UNITED STATES PATENT AND TRADEMARK OFFICE

Office Action Summary

10/564,739

DETAILED ACTION

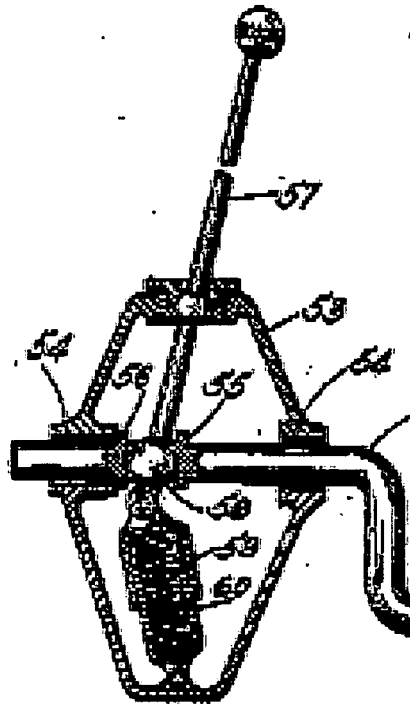
Cooper teaches a control member (Fig. 3, see attached partial view) composed of at least two abutting segments (57, 59) articulated to each other (Fig. 3), namely a proximal segment (57) constituting a control stick (57) and a distal segment (59) formed of an elastically deformable member (60) that bears articulatedly against a casing (53) to constitute an assist member (C2 L58-67) such that in the idle position (vertical

position), said control stick and said assist member are disposed coaxially in prolongation of each other (Fig. 3) for the purpose of urging further inclination of the lever when inclined from the vertical position (C2 L58-67).

Re clm 2: Cooper further discloses said assist member is a device comprising compression springs (60) and gas cylinders (59 is a cylinder comprising air).

Re clm 3: Cooper further discloses said assist member (59, 60) being a gas cylinder (59 is a cylinder comprising air), it is articulated at its corresponding bottom and head ends (Fig. 3) to a respective one of said casing (53) and said control stick (57).

Re clm 4: Cooper further discloses said assist member is articulated omnidirectionally to said casing and to said control stick by means of respective ball joints (58 and upper ball joint).
